TITLE OF PROJECT: **Anthony Hall – Replace Elevators 1, 2, 3 and 4**

PROJECT NUMBER: CP23041

ADDENDUM NO: 1

Addendum No.: **One (1)**

A2.2

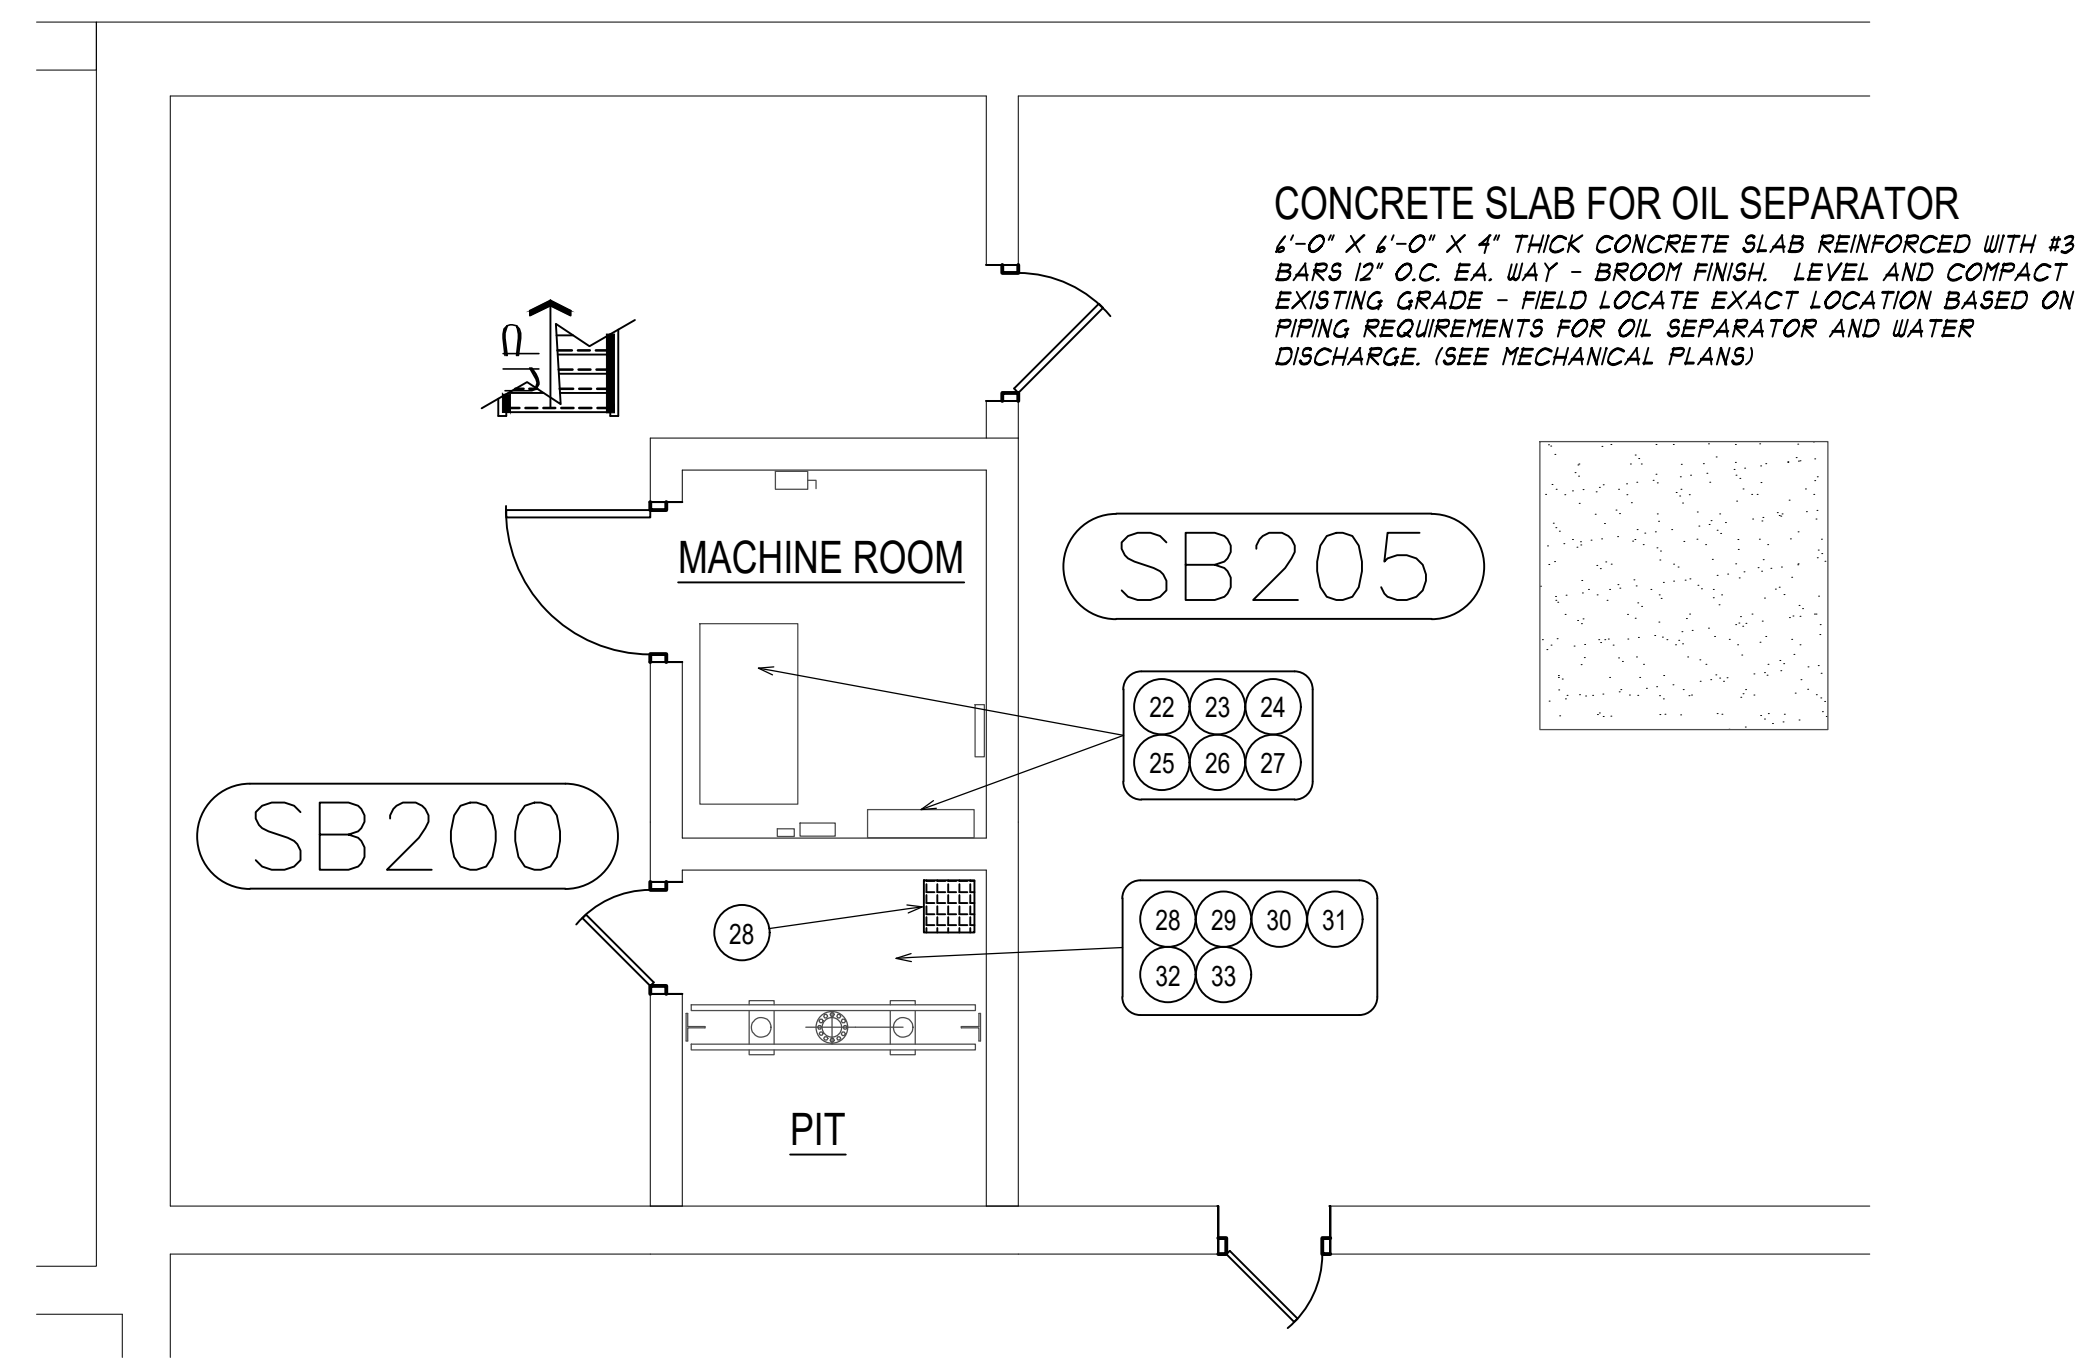
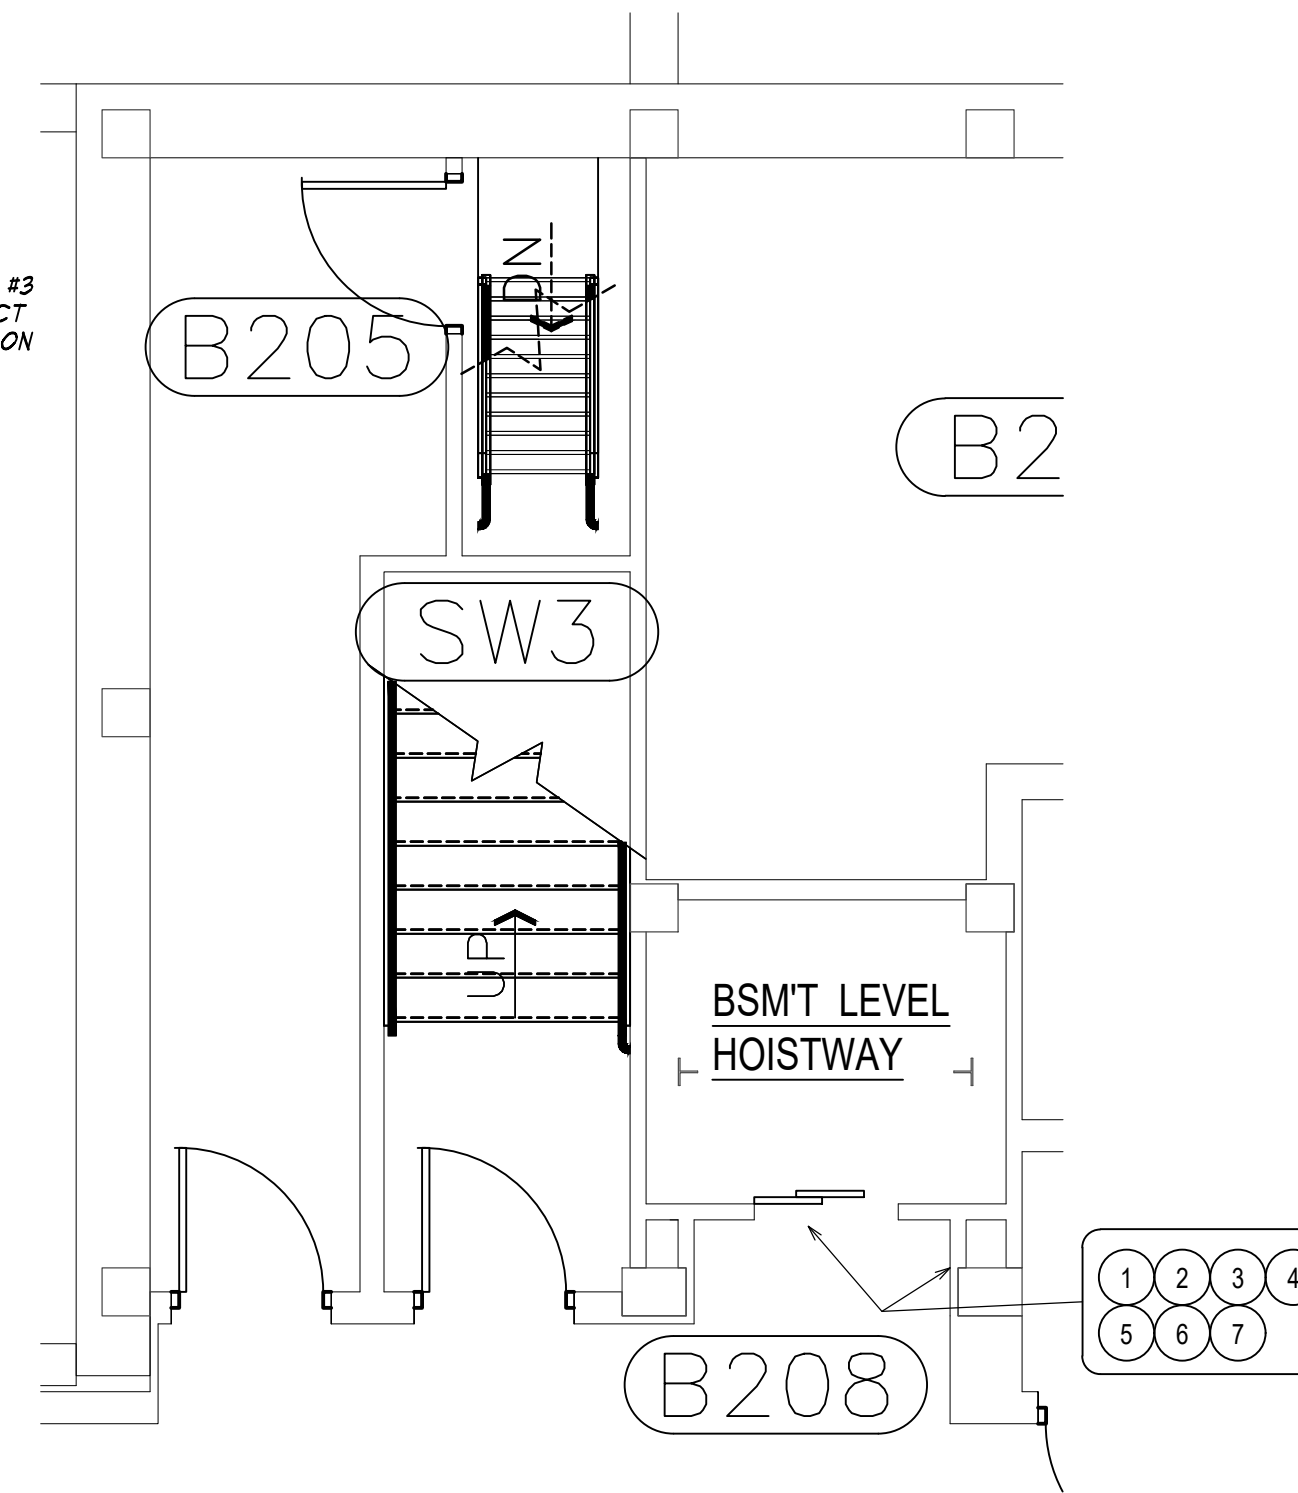
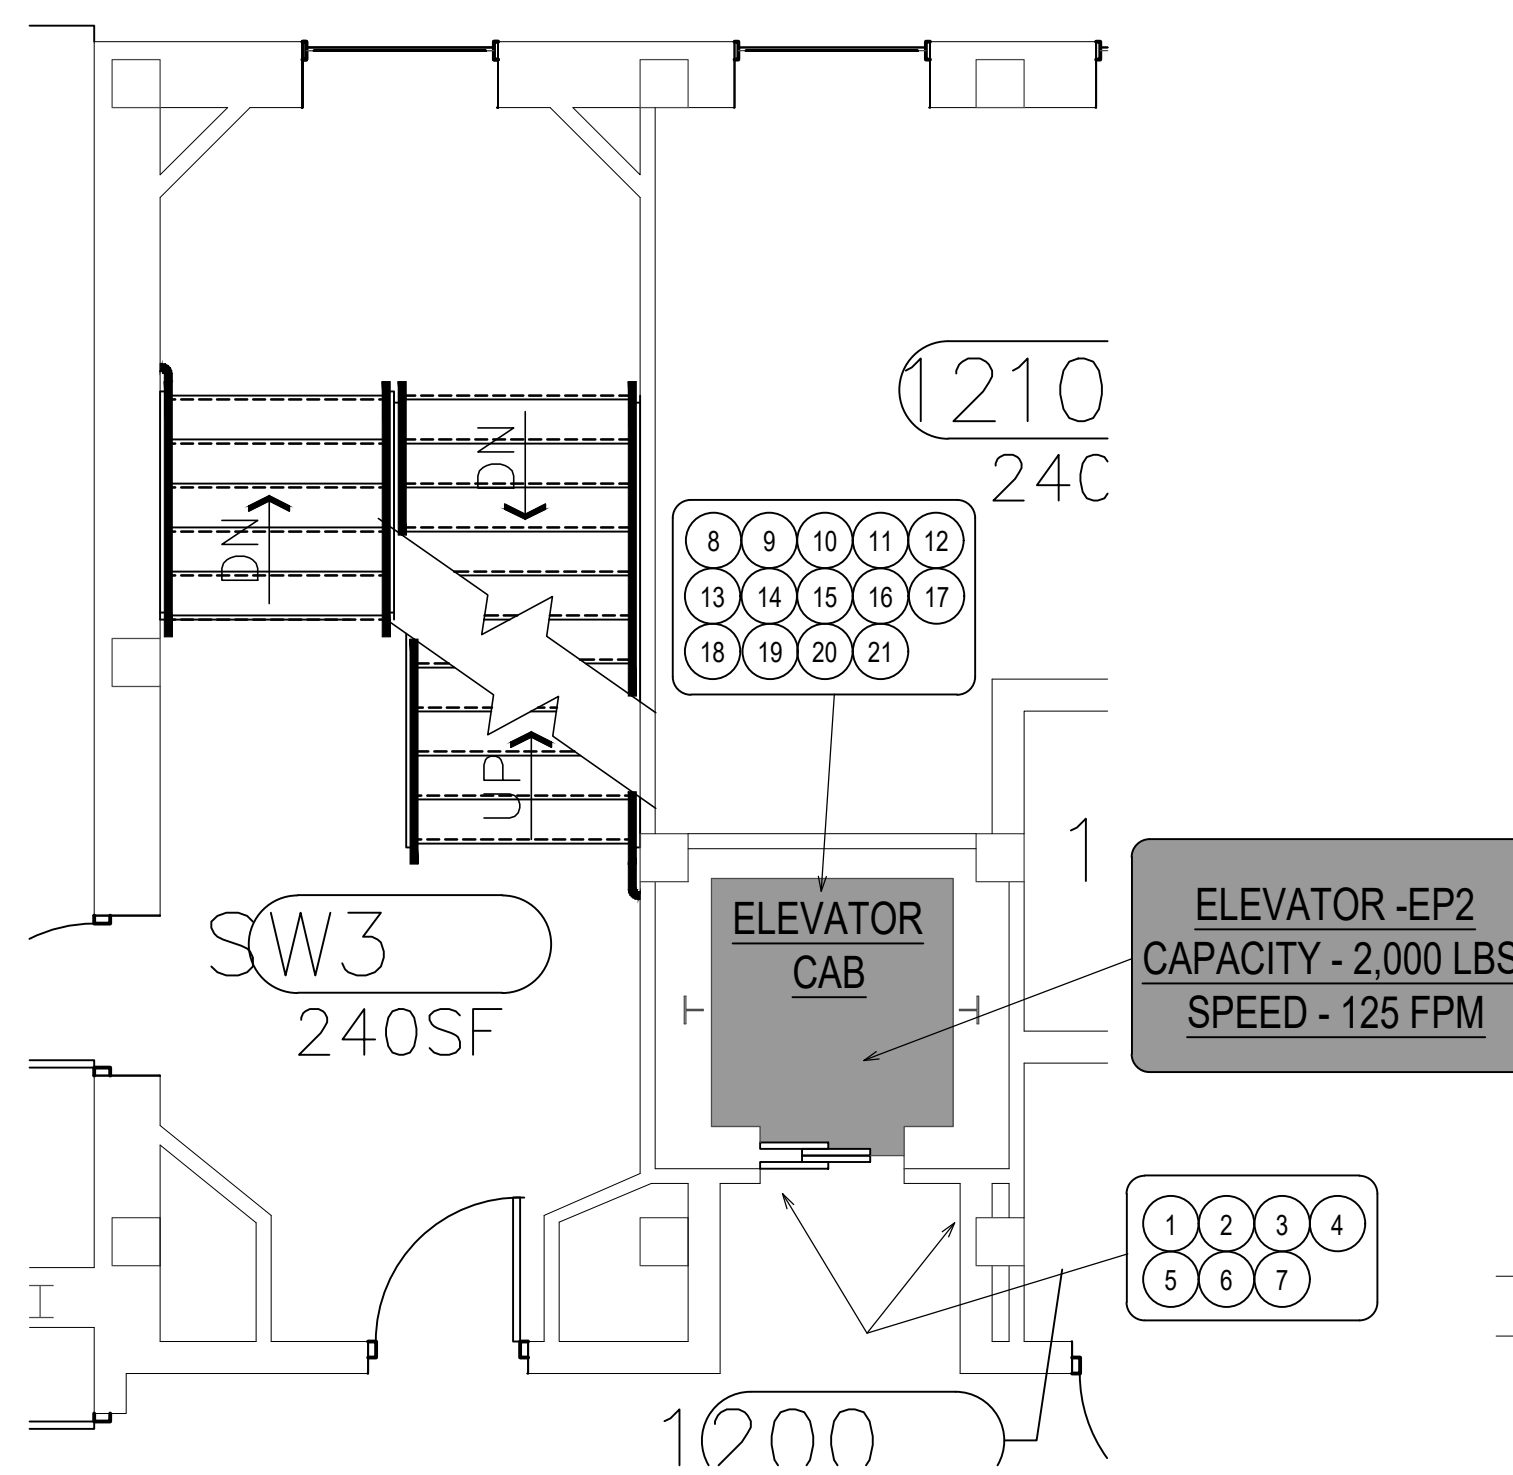
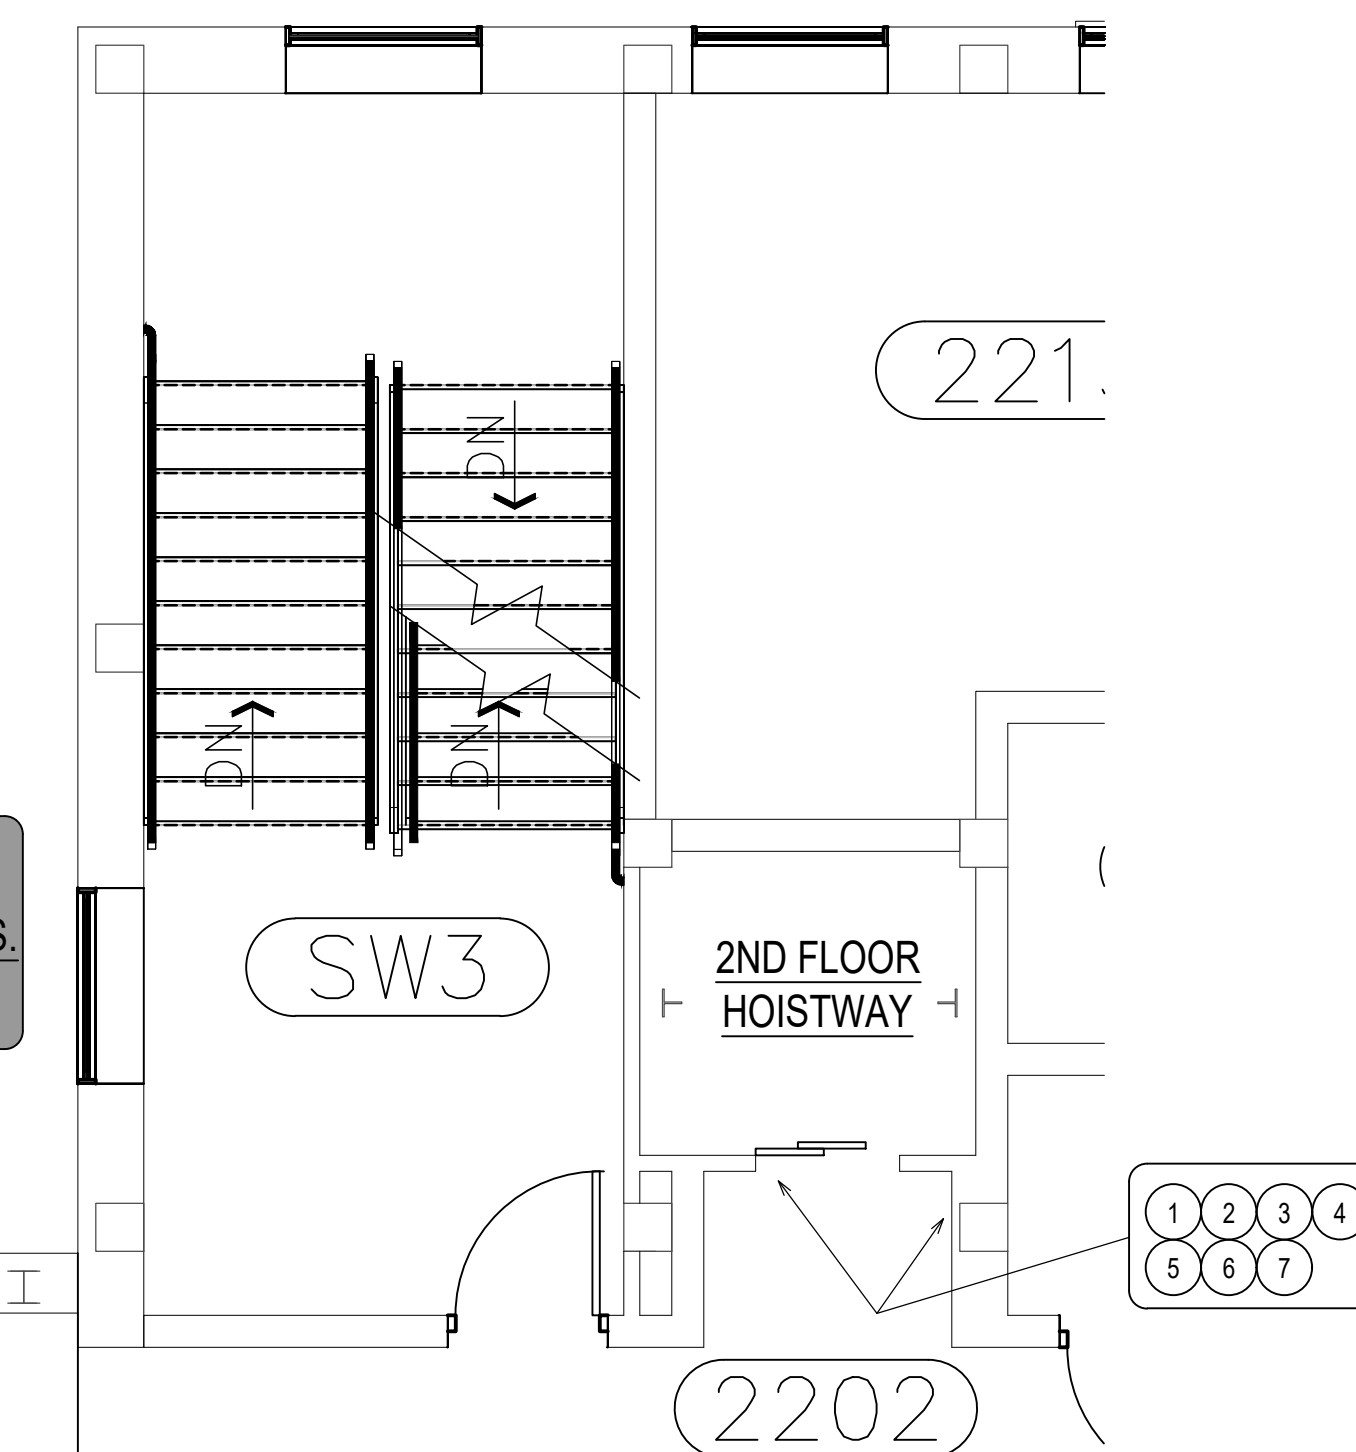
Item #2 **Reference:** *Drawing Sheet A2.1 and A2.2 (issued)*

The original drawing sheets referenced above included the incorrect schedules. The above drawing sheets listed containing an Addendum date of 2023.11.01 are issued with this Addendum with the correct schedules.
